Addendum #1

Ridley Park Sports Complex Expansion – Softball Bleacher Package 2
Columbia, Tennessee
Lose# 15219

August 26, 2016

Enclosed you will find our final construction plans for the Ridley Park Sports Complex Expansion Softball Bleacher – Package 2. Below you will find our response to Engineering and Codes comments to this set:

SHEET TITLE
 DEMOLITION PLAN

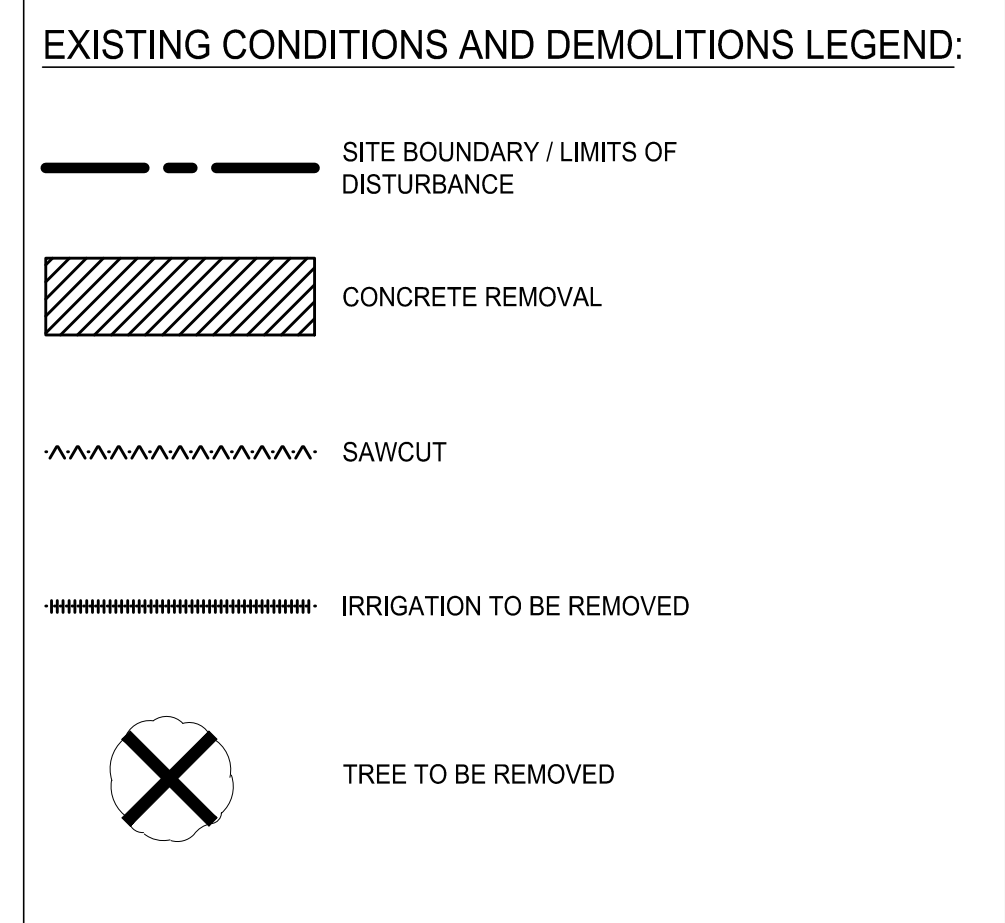
1. Sheet C0.10 calls for two trees to be removed. Verify these trees are there.

1. Sheet C0.10 – Concrete area for electrical and data connection has been revised.
2. Sheet C0.10 – Note and sheet references to notes 11 and 12 have been corrected.
3. Sheet C1.01 – Note and sheet references to notes 7 and 8 have been corrected.
4. Sheet C1.01 – Concrete area for electrical and data connection has been revised.
5. Detail 1/C4.00 – Geotextile Fabric has been removed from table.

Through site photographs taken on 6/2/16, trees to be removed have been verified.

3 CONCRETE PAVEMENT (HEAVY DUTY)

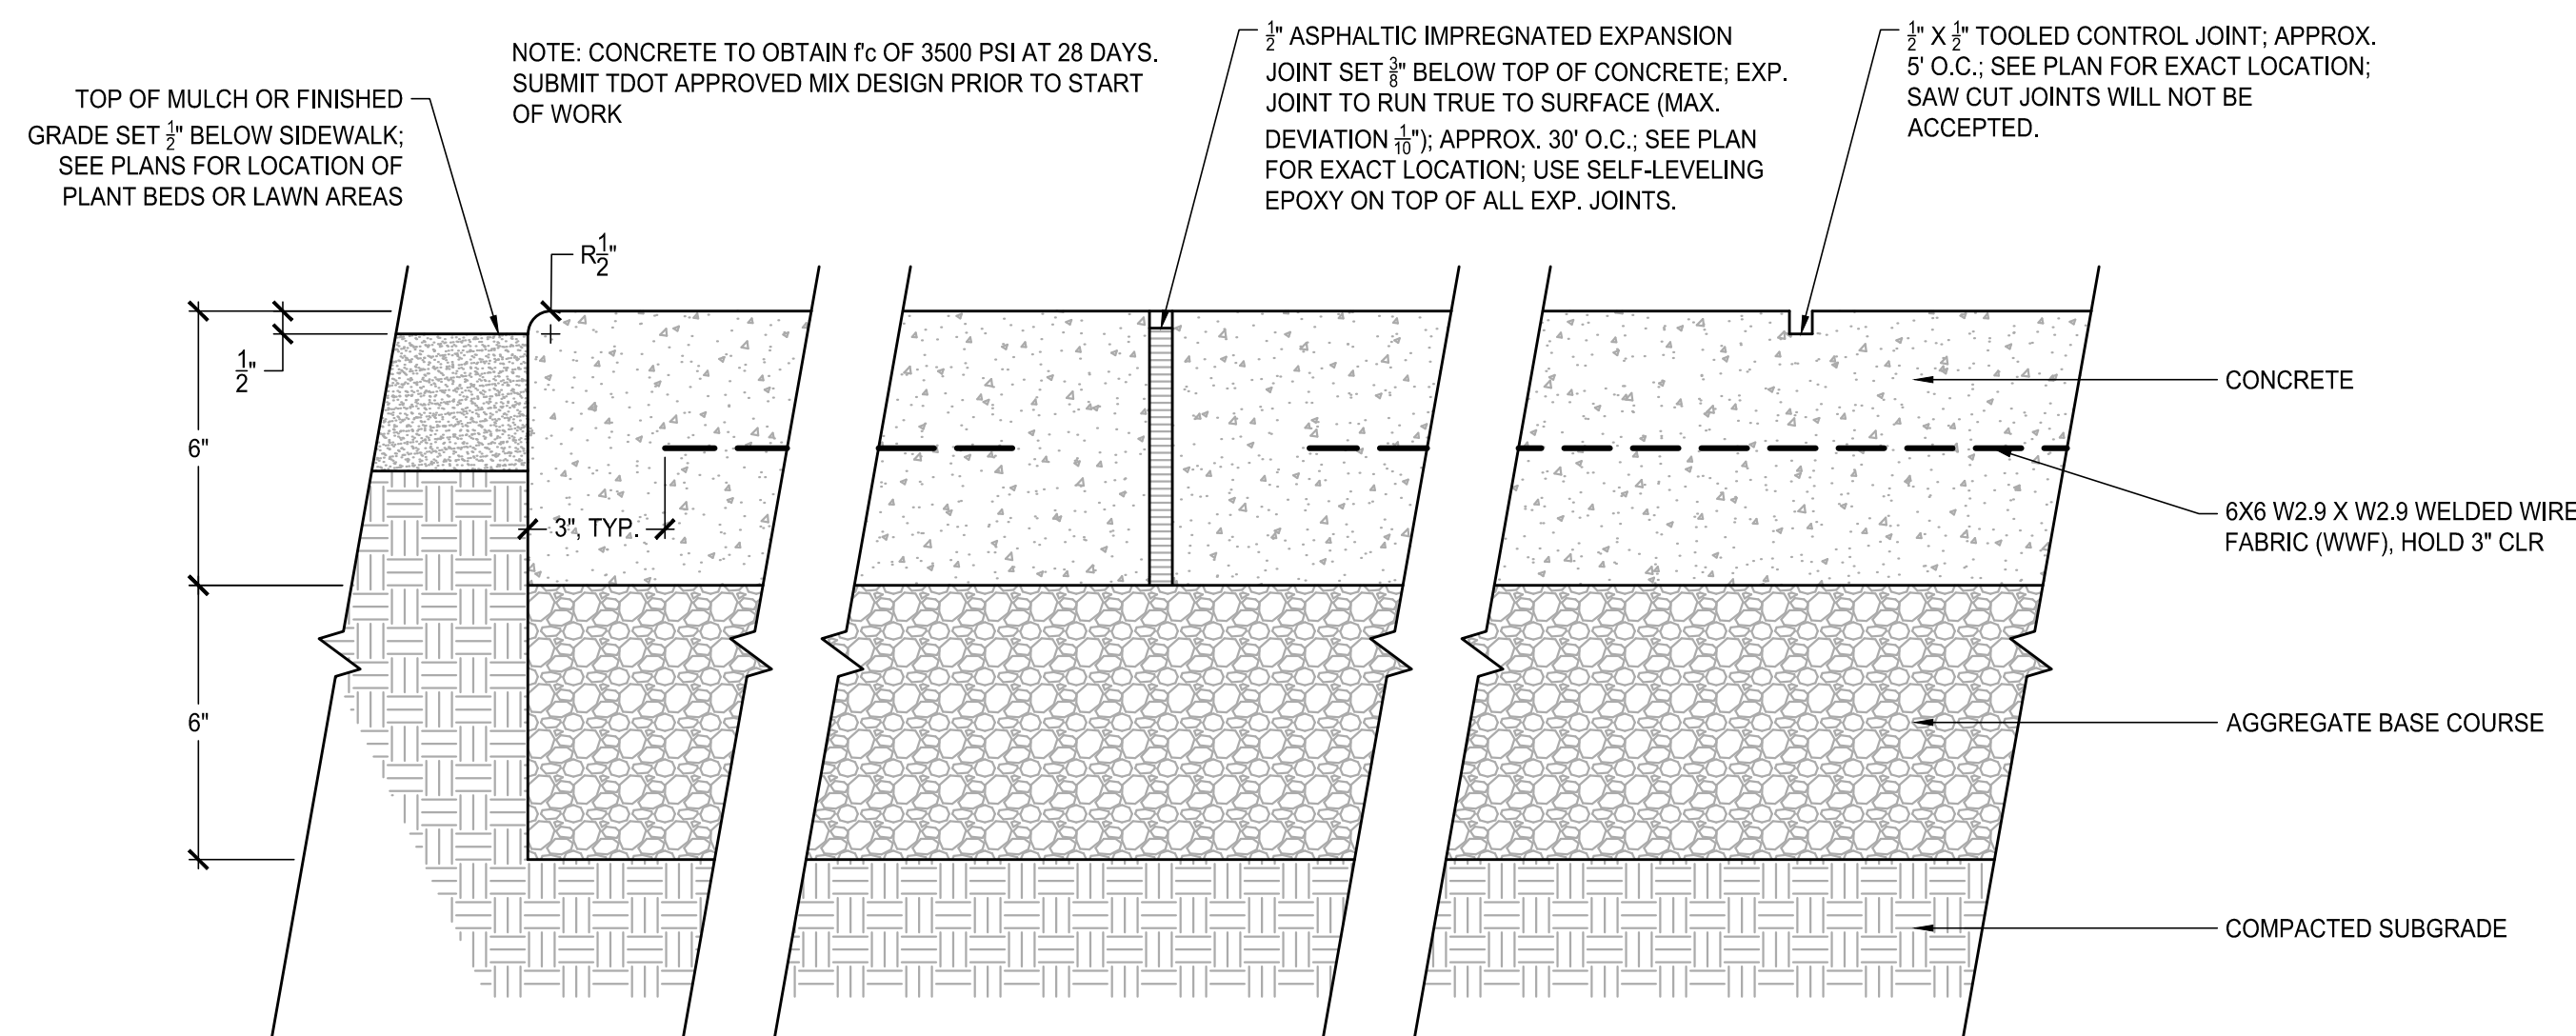
3. Sheet C4.00, Detail 3 – Specify what size WWF is to be used.

Detail 3, C4.00 has been revised to show "6X6 W2.9 x W2.9 WELDED WIRE FABRIC (WWF),..."

SHEET NUMBER	A-1F
PART NUMBER	0236403
	236403

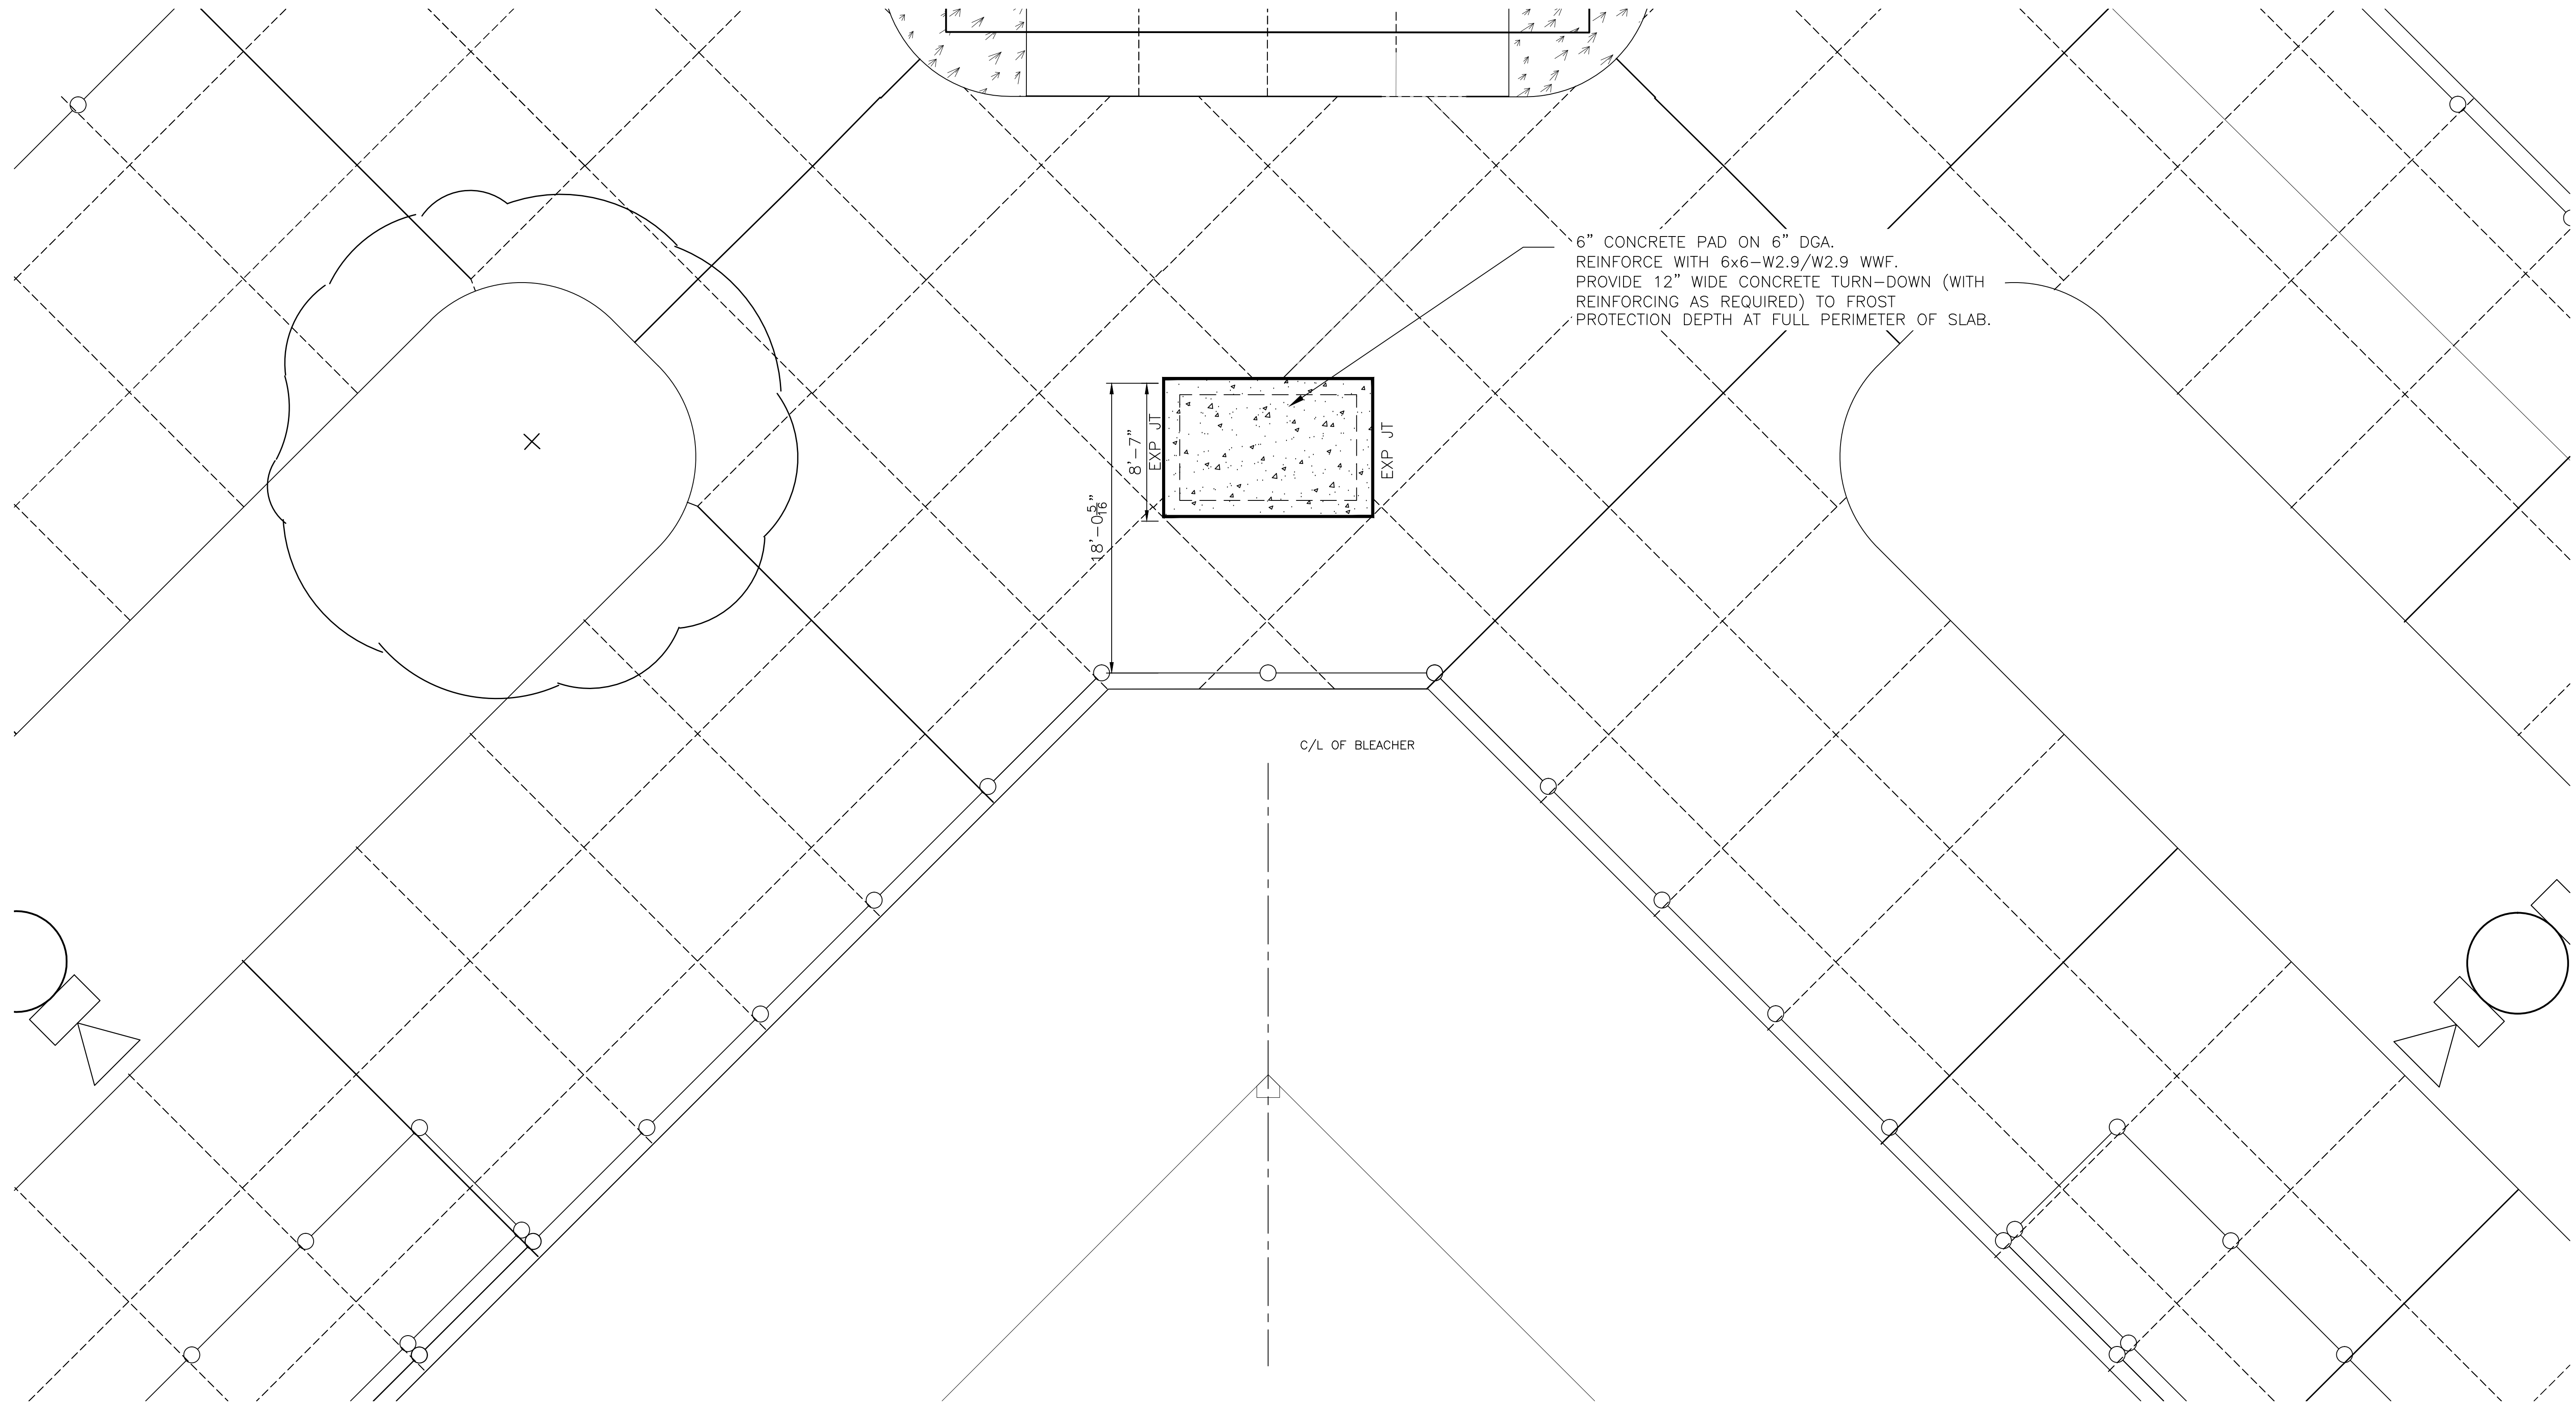
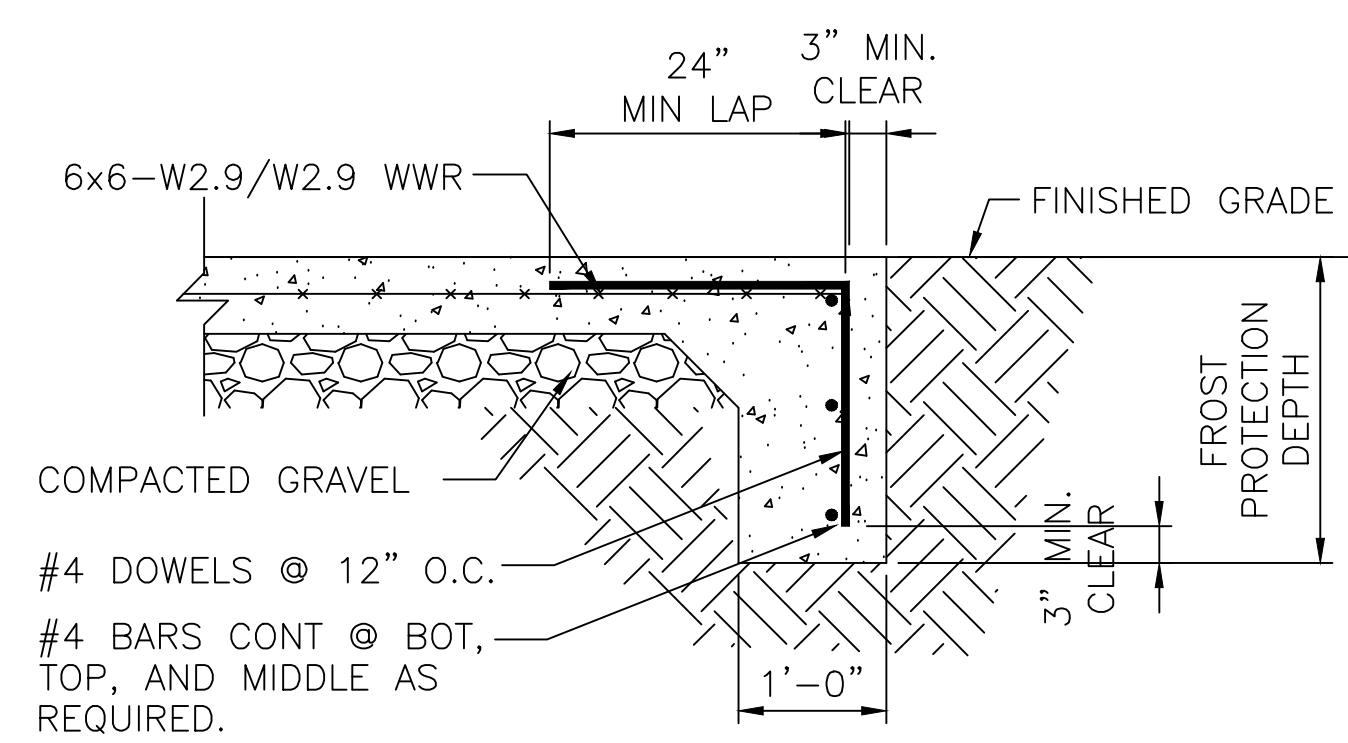
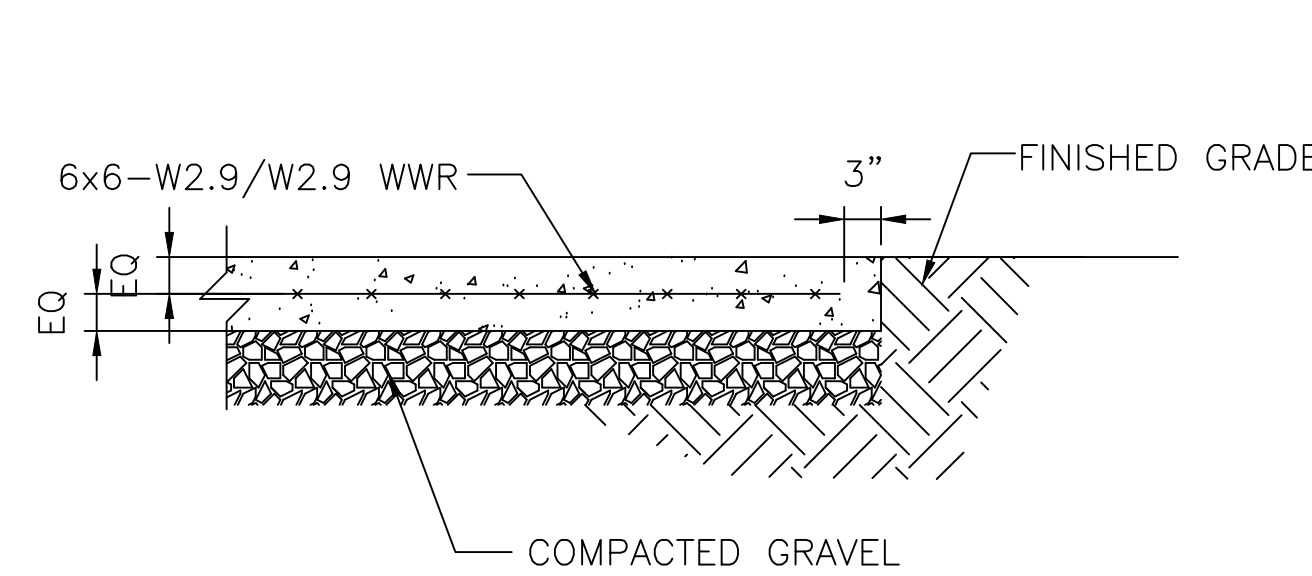
4. Sheet A-1F shows concrete different than what is shown in the layout plans. Make sure these sheets coordinate. Use the same size WWF as Detail 3/ C4.00.

Sheet A-1F has been revised to show existing concrete and only concrete work to be performed by contractor. WWF in details 2/F-1 and 3/F-1 have been revised to match.
